Landscape Review Committee

DATE: April 20, 2022
TO: Landscape Review Committee Members
FROM: Monica Bilodeau, Senior Planner
SUBJECT: Landscape Plan Review Application (L 31-21)

This proceeding is a review of the Oak Ridge Meadows Subdivision landscape plan and private park plan (L 31-21). Staff has reviewed the application for consistency with the applicable criteria, and recommends approval of the application, subject to the conditions specified in the attached Decision Document.

DOCKET: L 31-21 (Landscape Plan Review)

L1.1
SHEET 2 OF 8
PROJECT # 1830R

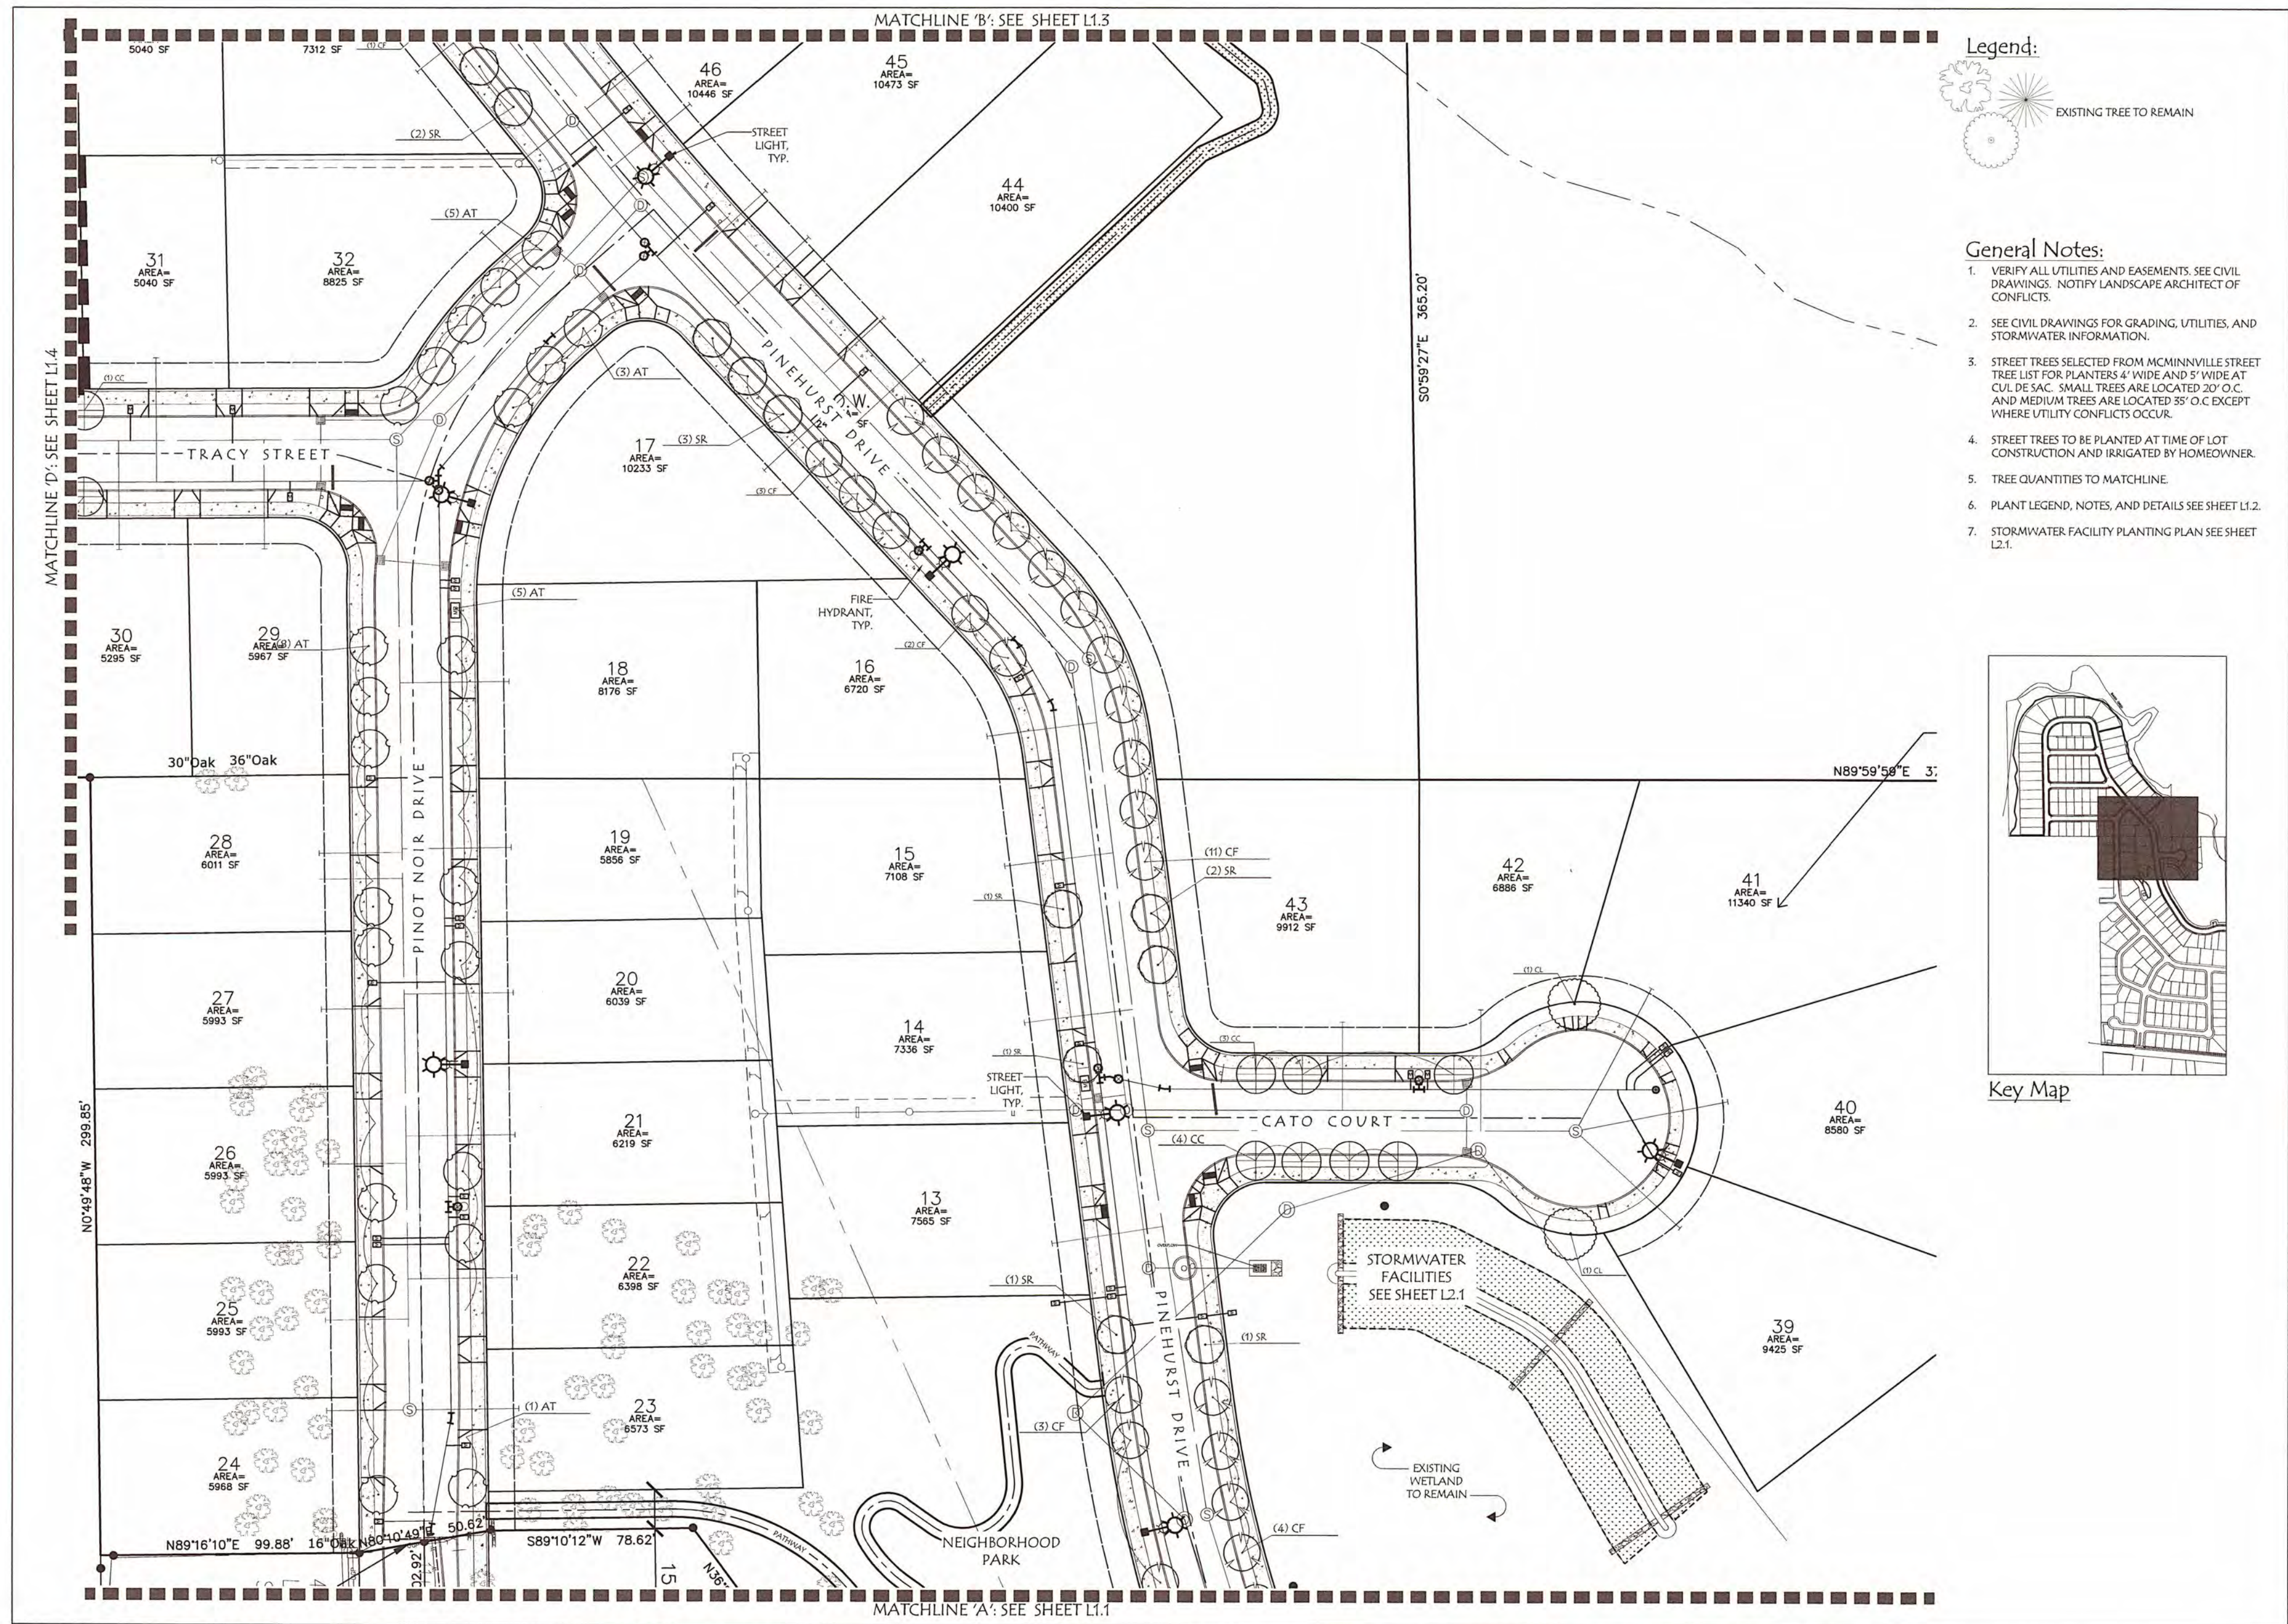
Sheet L-1

L1.2
SHEET 3 OF 8
PROJECT # 1330R

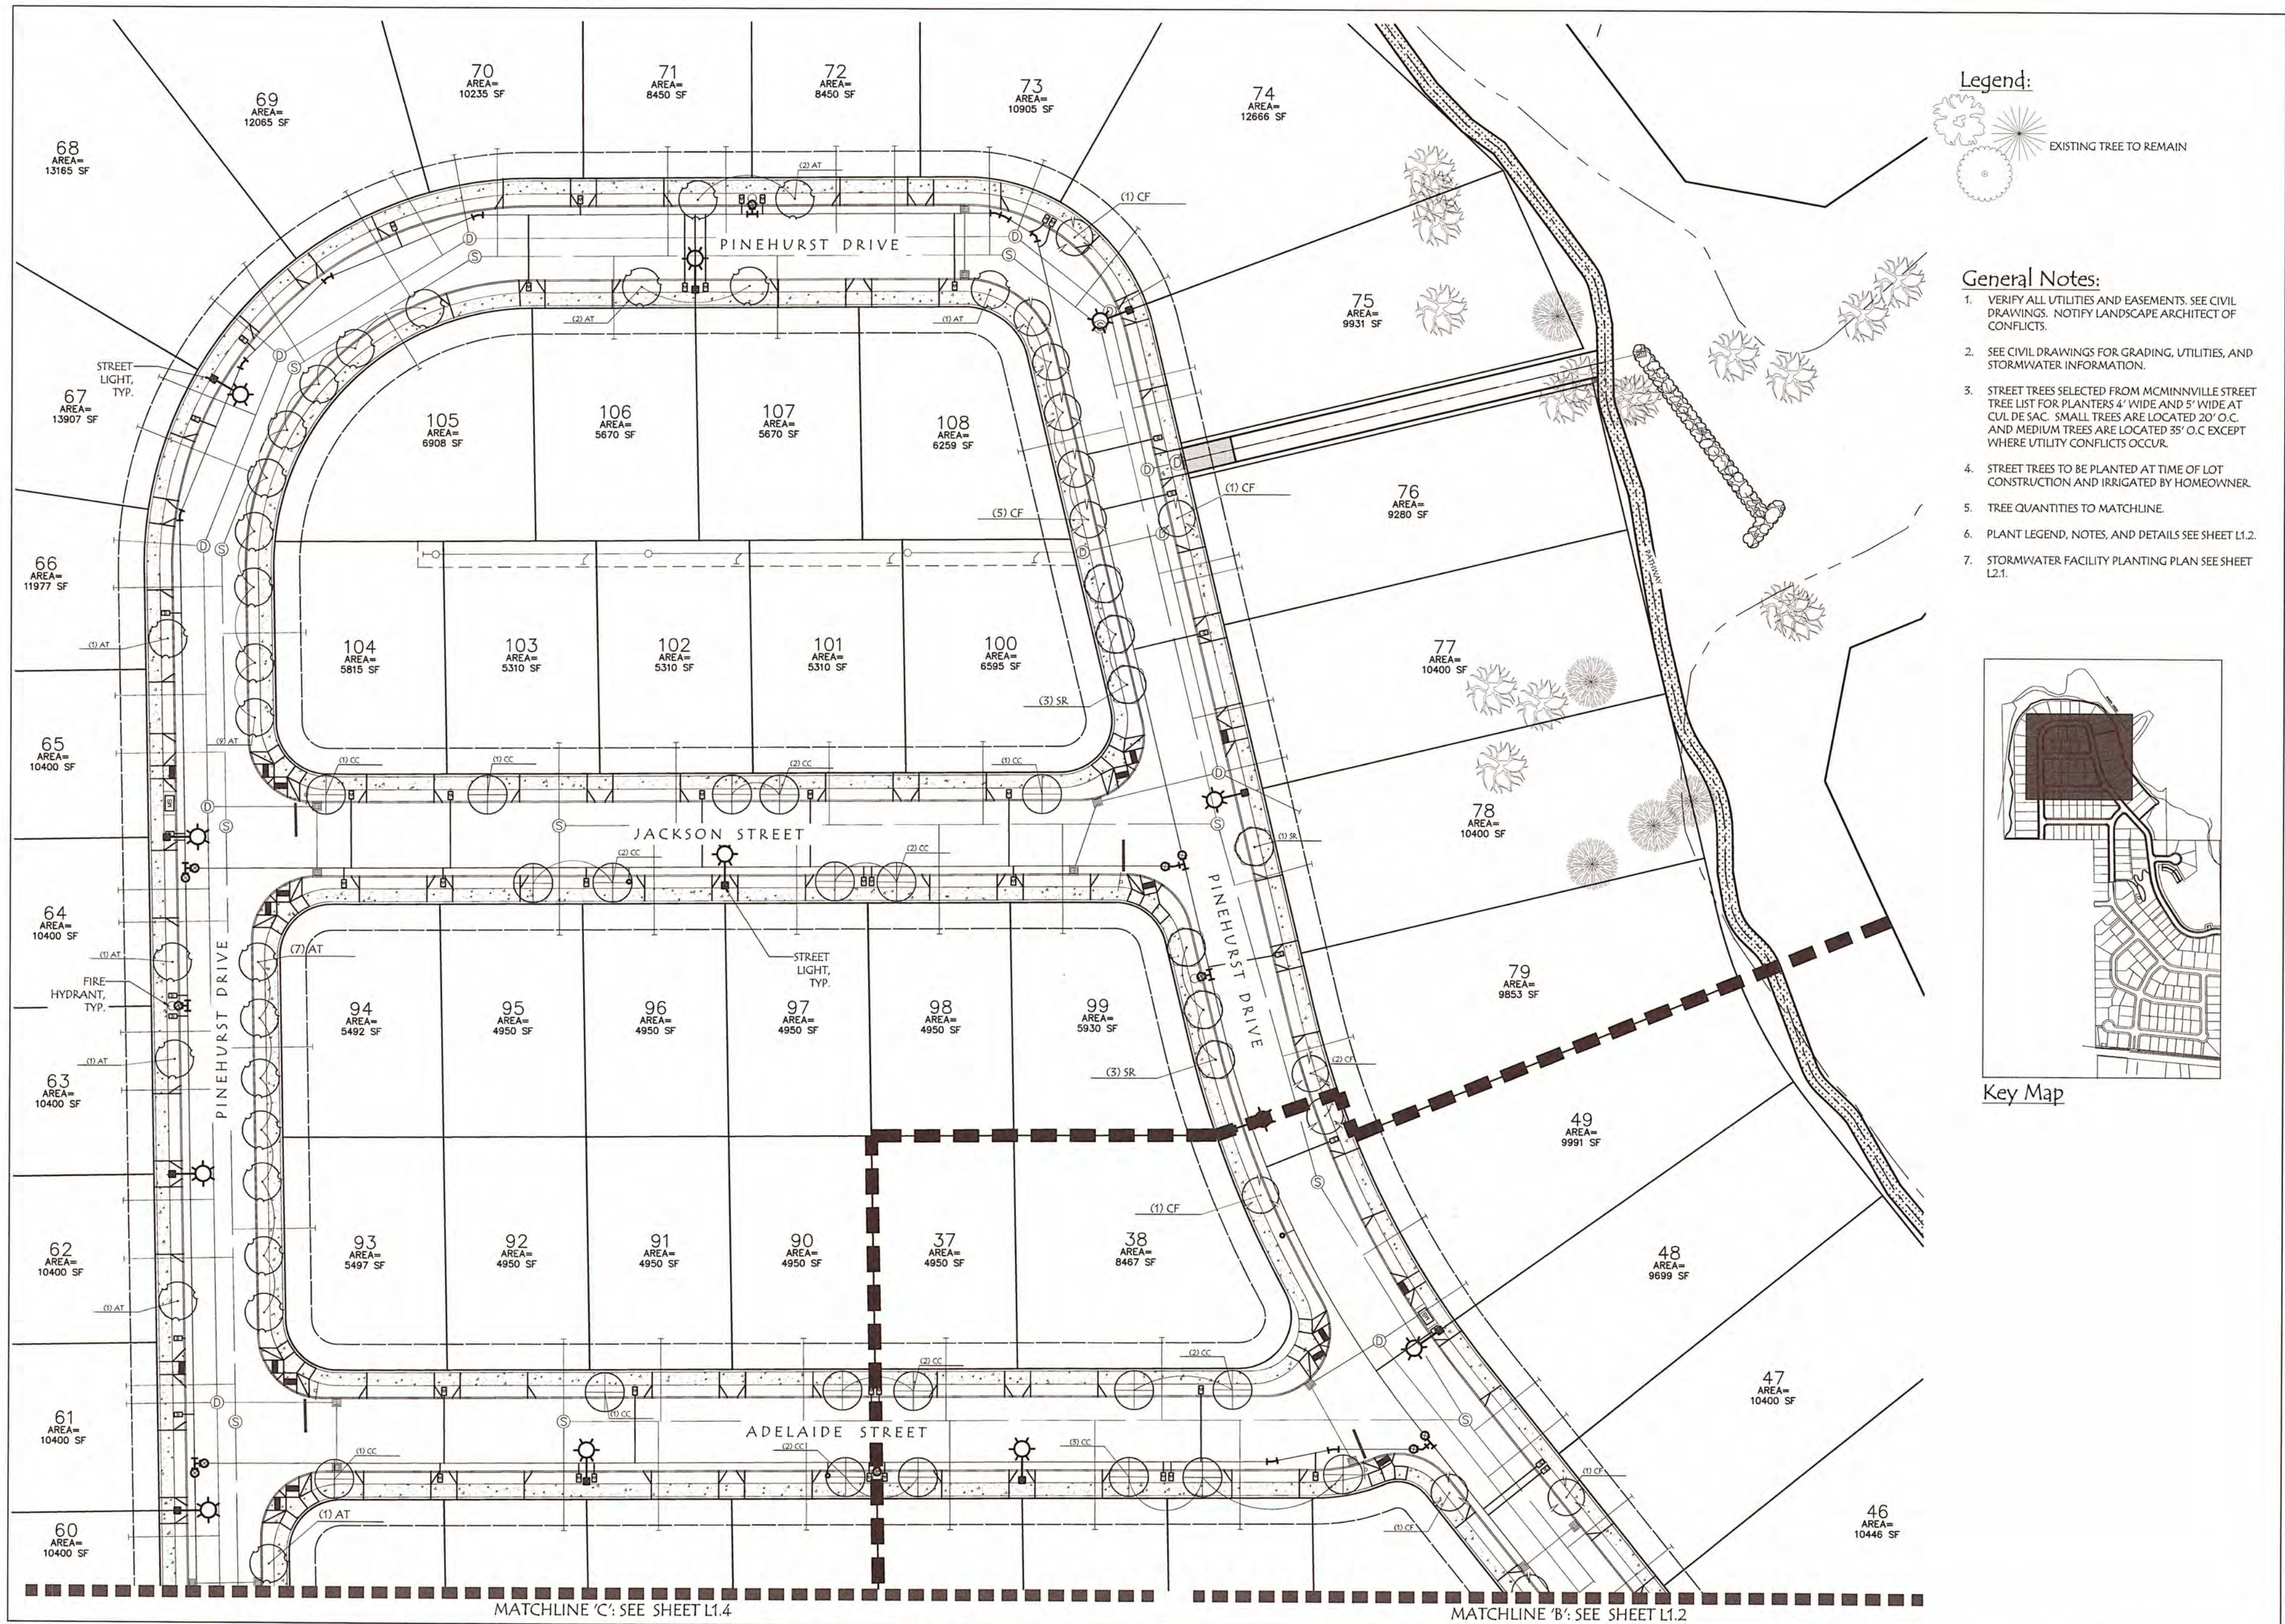
Sheet L-1.2

L1.3
SHEET 4 OF 8
PROJECT # 1330R

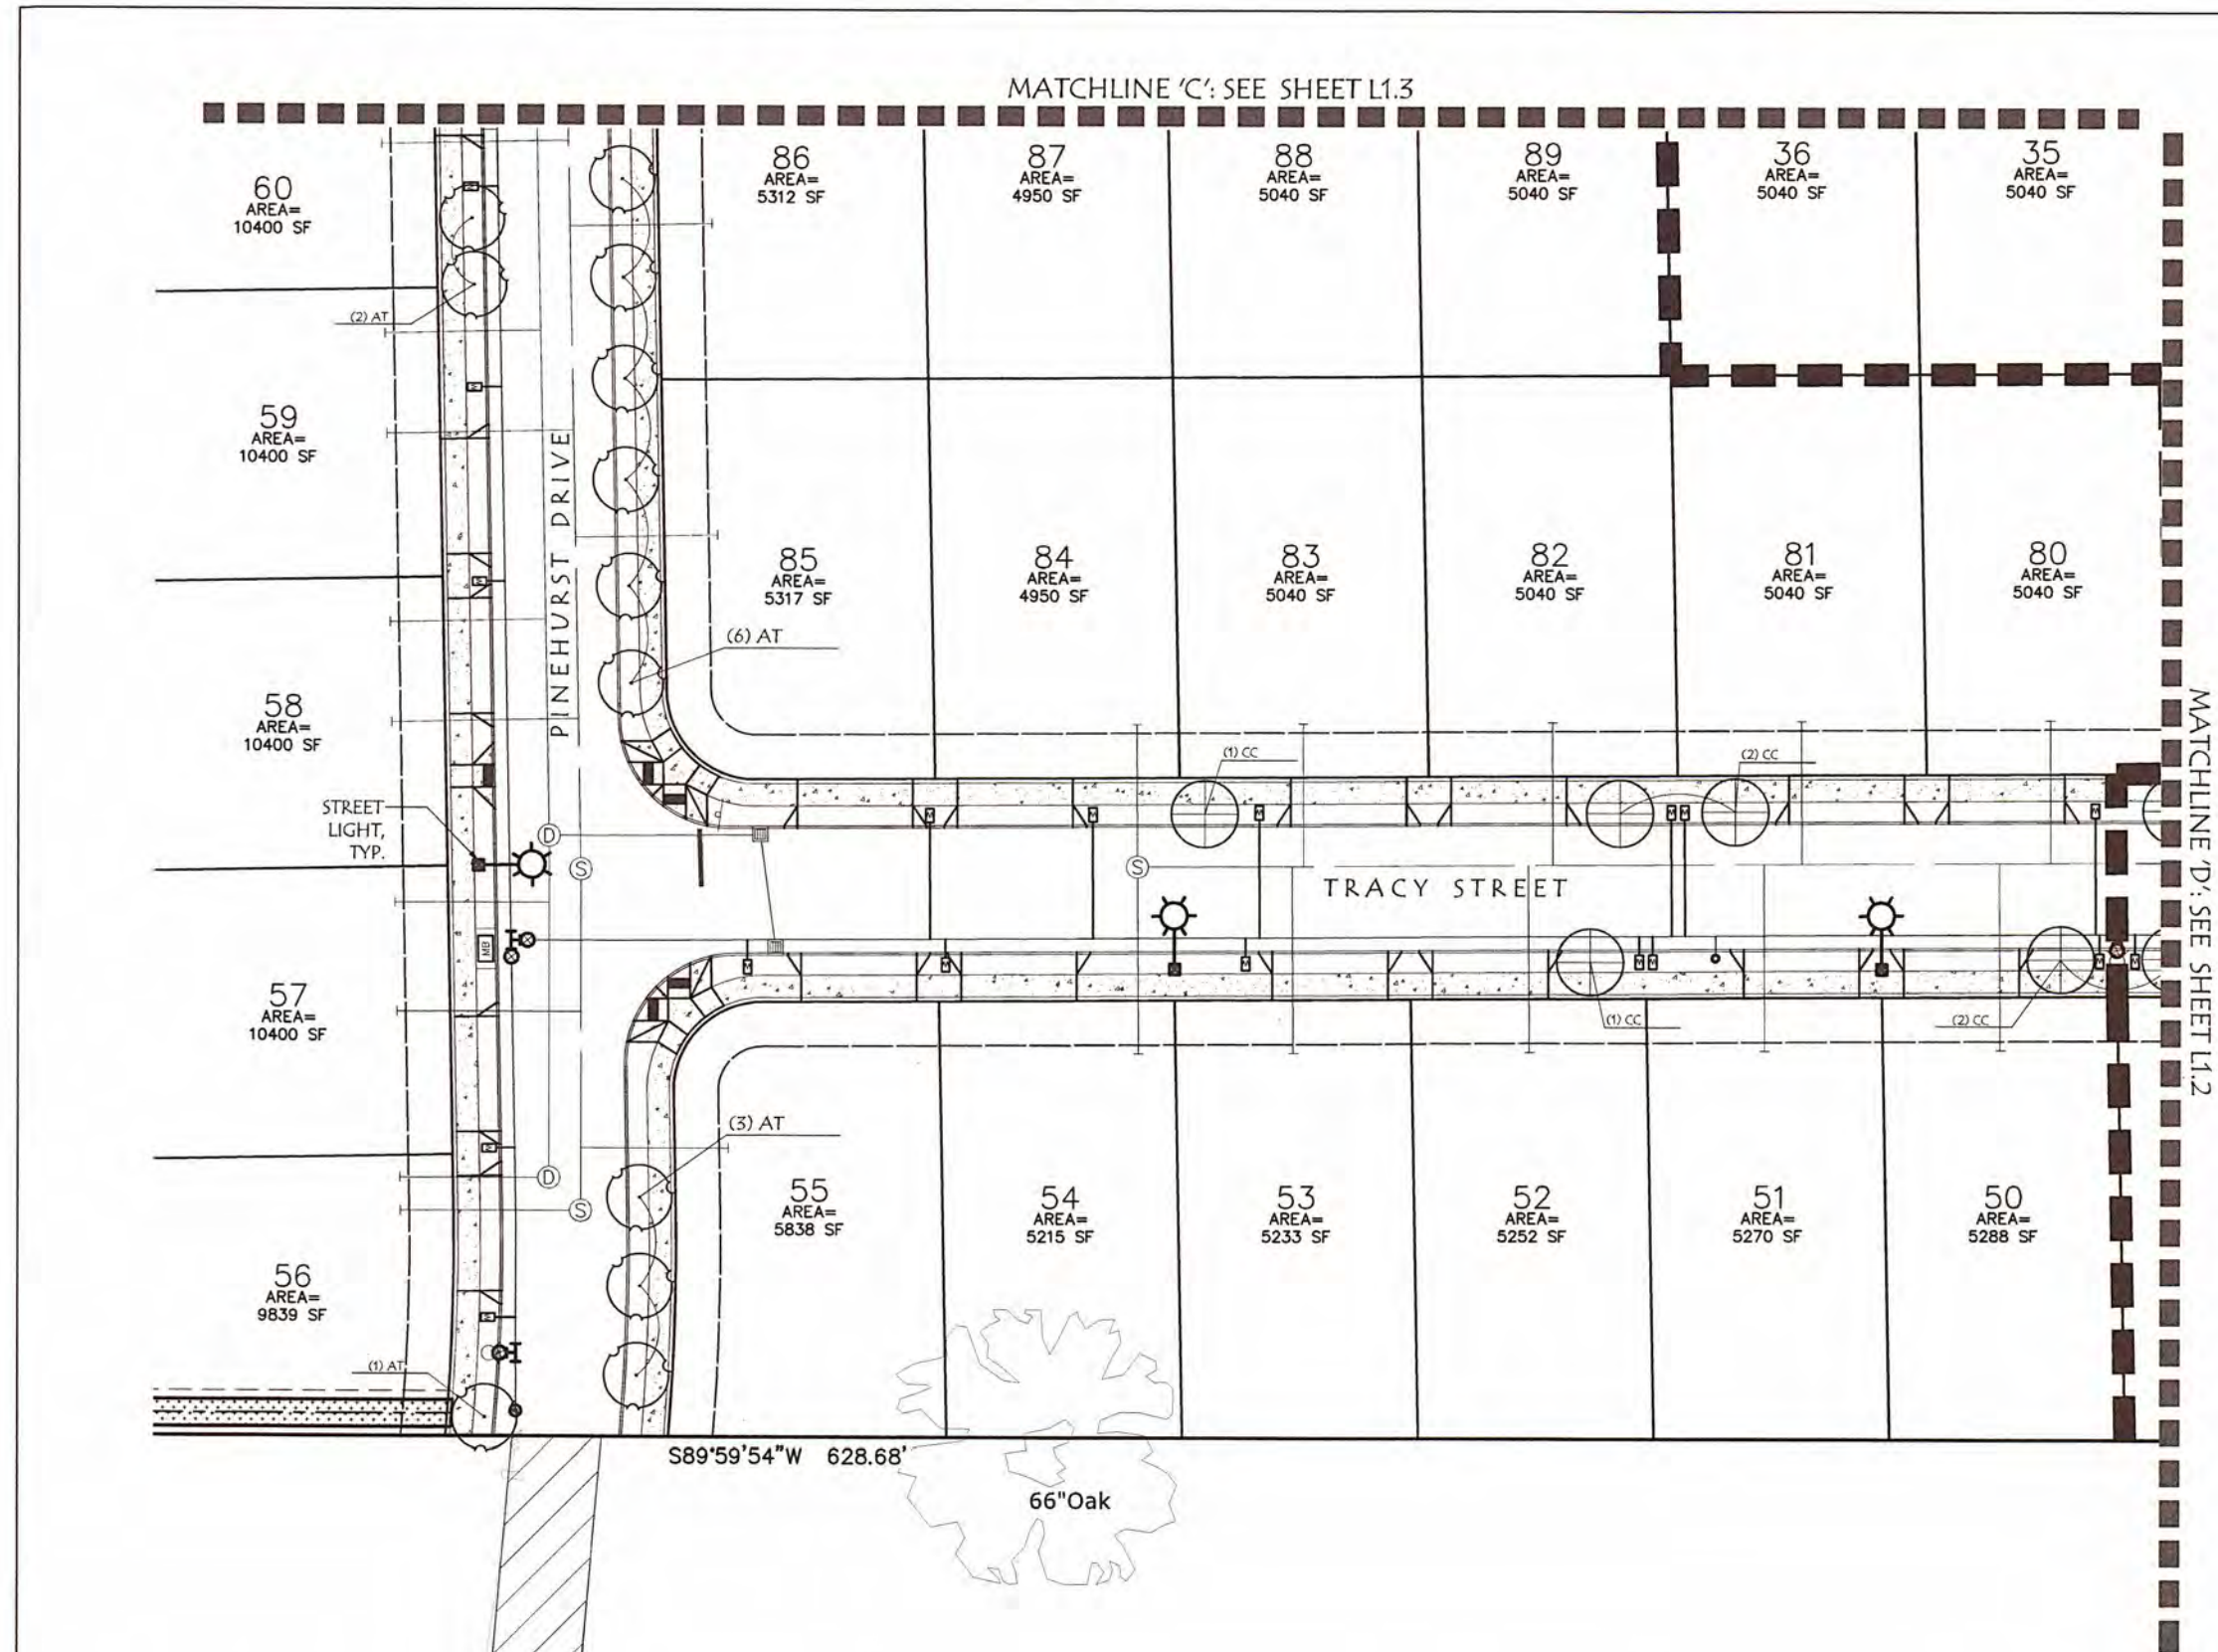
Sheet L-1.3
